DEVELOPMENT REVIEW COMMITTEE MINUTES

Park View Condominiums

ENGINEER REVIEW COMMENTS
PARK VIEW
200 SOUTH 300 WEST

SITE PLAN REVIEW #2	
PLAN RECEIVED DATE:	NOVEMBER 28, 2014
PLAN REVIEW DATE:	DECEMBER 9, 2014
DATE RETURNED TO DEVELOPER:	DECEMBER 16, 2014

SHEET NO.		3
GRADING PLAN		SANTAQUIN, UTAH
<p>PARK VIEW</p> <p>PHONE: 801-233-0066 FAX: 801-233-0068 111 WEST 200 NORTH #2 SPANISH FORK, UT 84660</p>		
<p>OWNER/DEVELOPER SCOTT PETERSON 95 WEST 200 NORTH #2 SPANISH FORK, UT 84660</p>

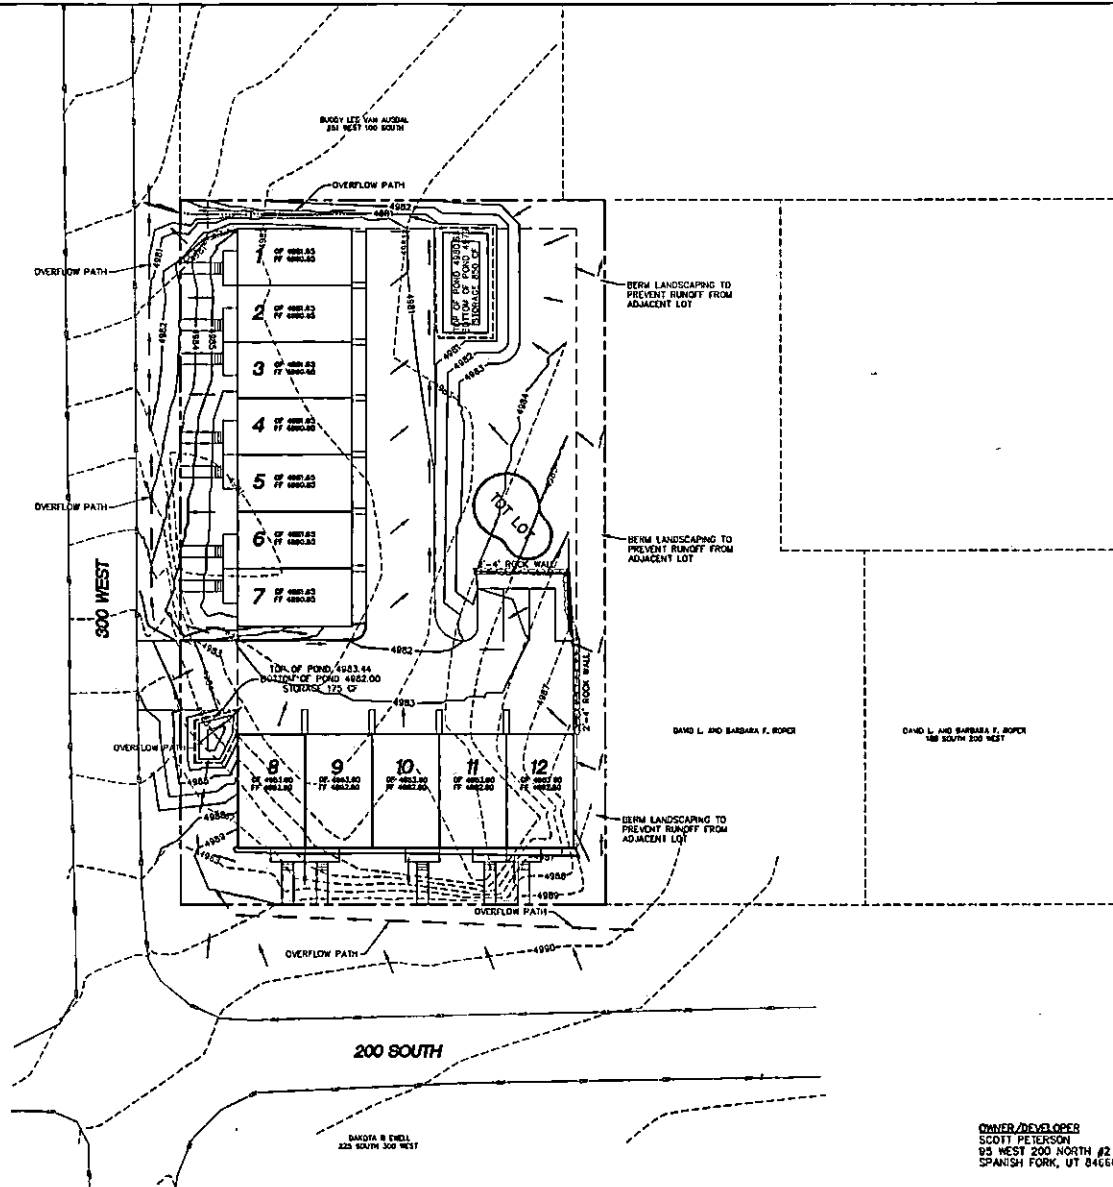
1. Discuss storm water within Basin #3. There is a large amount of impervious area (the west half of the north building, sidewalks, etc.) that needs to have the storm water routed and retained onsite. This water is not allowed to run into the public ROW for routing or percolation. Please provide storm drain calculations and details for routing and retention onsite for Basin #3. There may need to be a depression area along the north property line for infiltration.

2. Discuss storm water coming from 200 South & 300 West. During DRC held January 14, 2014 it was discussed that storm water from both streets could/would affect this property. Are sufficient measures planned to prevent possible flooding of the units?

3. Discuss phasing. If phase 1 is to be constructed before (not concurrent with) phase 2, storm drainage facilities for Basin #2 will need to be constructed as part of phase 1. Would it be prudent to change the phase line to continue northbound to the north property line?

How will storm water from the driveway areas of phase 1 be routed to Basin #2 retention area? Erosion control measures may be necessary west of the tot lot.
4. Discuss what is planned for the transition between the parking and driveway areas and adjacent landscaping. City code requires curbing where driveways and parking areas abut landscaped areas.
5. Please show rip rap or other erosion control measures where storm water enters each retention area.
